Longacres, Eastergate Lane, Walberton, Arundel, BN18 0BA

Drainage Technical Note

1. This Technical Note has been prepared to address the LLFA's objection comments – as set out in the "Engineers' Comments Regarding Surface Water Drainage" document dated 02/05/25, refer to Appendix C.

P2	Amended with external areas		30/05/25	JMW	JP
P1	INITIAL ISSUE		04/03/25	JR	FVV
Rev	Amendments		Date	Dsn	Chk
Status					
PRELIMINARY					
Client					
MR AND MRS PEARCE					
Architect					
DOUGLAS BRIGGS PARTNERSHIP					
Project					
LONGACRES EASTERGATE LANE					
Title					
IMPERMEABLE CATCHMENT PLAN					
Date		MARCH 2025		Scale @ A1	
				1:200	
Clients Ref.		Project Ref.		13467	
 Civils & Transport Maple House, 192-198 London Road, Burgess Hill, West Sussex, RH15 9RD Tel.01444 871444 Web: www.gtacivils.co.uk					
Drawing Number				Rev.	
13467/1102				P2

Drainage Strategy Layout & Catchment Areas Plan

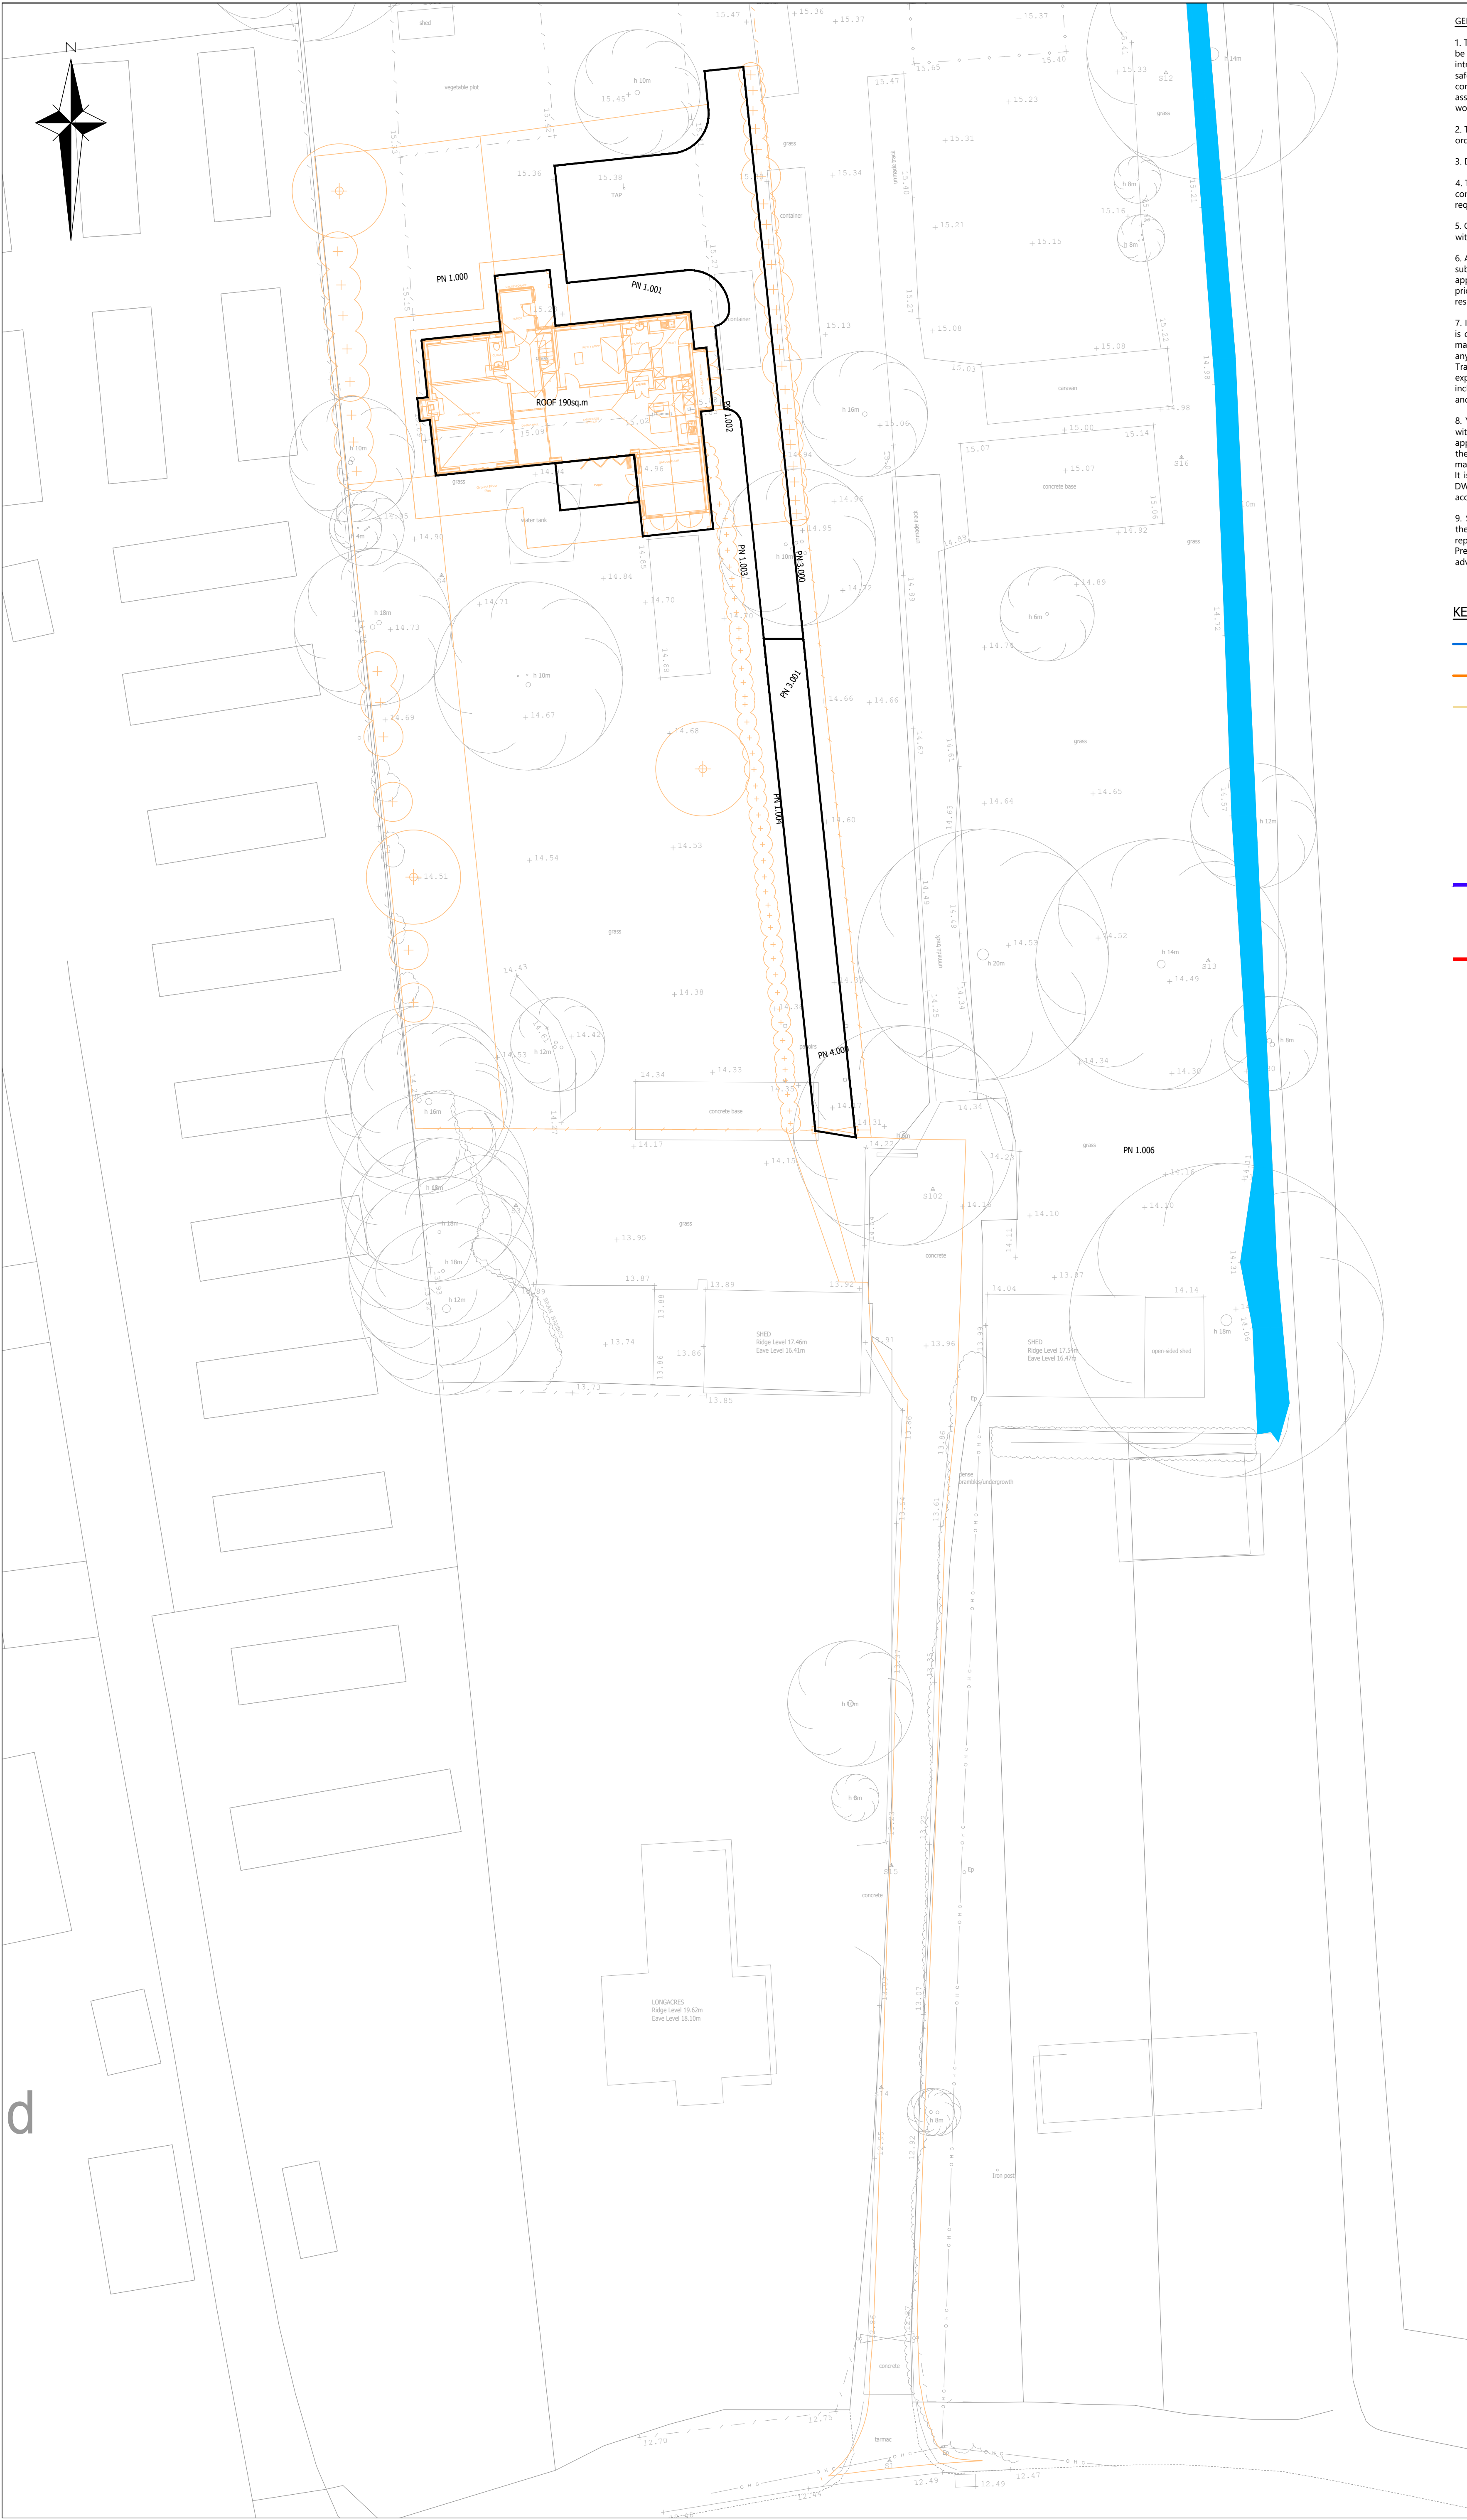
1. *The routing of pipework through the root protection zone of a mature tree. Given the species of tree, the roots could be detrimental to the operation of the pipeline in the future. Our tree officer will provide a consultation in this respect.*

2. *It is understood that the existing driveway will remain in its present form, however, it is noted the any new sections of driveway/hardstanding will be constructed with a permeable surface. The principle is acceptable, however, the new areas will need to be an engineered design. Thus, they will need to be incorporated within the overall drainage design.*

3. *The proposed discharge rate (QBAR) appears to have been calculated on the entire site area rather than just the impermeable area. This will need to be re-calculated accordingly (to also include the new driveway/hardstanding contributing areas) and a discharge rate agreed. Due to the low rate expected and potential orifice diameter, suitable measures will need to be put in place to reduce the risk of blockage.*

4. *The hydraulic calculations do not reflect the current design in terms of levels. However, the calculations need to be revisited as a result of the above, and must include the piped network and evidence of the impermeable areas used. Urban creep @ 10% also needs to be applied. Appropriate climate change allowance needs to be applied to all storm events. A surcharged outfall will need to be modelled. The surcharge level should be to the top of the bank if hydraulic modelling of the watercourse is not available.*

5. *An exceedance overland flow route plan needs to be provided.*
6. *No freeboard is being achieved between the proposed outfall pipe invert and the existing ditch bed. This is not acceptable as flood risk may be increased due to siltation and blockage of the outfall. Adequate freeboard needs to be achieved and agreed.*

7. *The proposed landscaping conflicts with the proposed drainage layout. For example, a tree is proposed in close proximity to the storage tank. The tree species and root protection zone at maturity will need to be shown to ensure no detriment to the structure. There is also new hedging proposed which could lead to root intrusion into the pipes beneath. This is important as tree roots could damage the liner and pipework, allowing groundwater to enter the system. This would consume storage that is set aside for surface water and thus increase flood risk.*

8. *Interception drainage has not been adequately considered by the submission. This is an important consideration as when the drainage system is designed in accordance with The SuDS Manual, runoff for the majority of small (frequent) events will be prevented from leaving the site. This is the first water quantity standard prescribed by the manual. Designing for interception is*

1. Following the tree officer's response to the application, the existing tree T1 (mature Eucalyptus tree) is to be removed as it is in poor condition and qualifies as 'unsuitable for retention' in the arboricultural report. On that basis, the proposed foul and surface water drain route can remain as shown without conflicts. The final leg of the surface water drain route to the existing ditch has been rerouted to resolve the conflict with the existing tree on the adjacent land. Appendix A includes the revised strategy layout.

2. The drainage strategy (in appendix A) has been revised to include the area of permeable paving. The drainage calculations are shown in Appendix B.
3. The offsite flow rate proposed in the submitted FRA report is based on the practical minimum limit of screened vortex devices. This rate is proposed because the Q_{bar} of 0.19l/s calculated for 1ha is considerably less. It is contended that a) there is no need for a greenfield calculation for the contributing area as this would show a lower rate, which would also be put to one side – and b) the risk of flooding would be increased if a screened vortex were designed for an offsite flow rate <1l/s. The orifice's diameter would be that small that buildup of twigs or other debris that manages to bypass the screen would increase the local flood risk – and this would be greater than any benefit of the reduction of flow rates <1l/s.

4. The drainage calculations have been updated to include 10% urban creep for the roofed area. The drainage calculations have been updated to reflect the complete proposed network as shown on the drainage layout in Appendix A. A 10% urban creep factor has been applied to all roof areas; an impermeable catchment plan is included in Appendix A. Climate change allowances have been applied to all events in accordance with the latest climate change guidance for the area. Additionally, a surcharged outfall scenario has been modelled for the 1 in 100-years +45% climate change event, to demonstrate that the network can cope when the ditch water levels are equal to top of bank levels – refer to the drainage calculation in Appendix B..

5. Exceedance flow arrows have been added to the drainage strategy layout – refer to Appendix A.
6. No freeboard is needed - because the SuDS drainage network has been designed to flow adequately in the surcharged condition – refer to the drainage calculation in Appendix B. The outfall has been designed to work in surcharged condition; and the drainage strategy now shows regrading of the ditch bed to achieve sufficient freeboard. This is shown on the layout plan and details will be covered by an OWC application in due course.

7. This item relates to the proposed landscaping. The proposed tank locations have been coordinated with the landscape proposals. Appropriate tree root barriers will be included as part of the works, in accordance with DCG recommendations for planting near drain pipes.

8. Water butts have been added to the drainage strategy. These are considered to be satisfactory interception features according to the CIRIA SuDS Manual (C753).
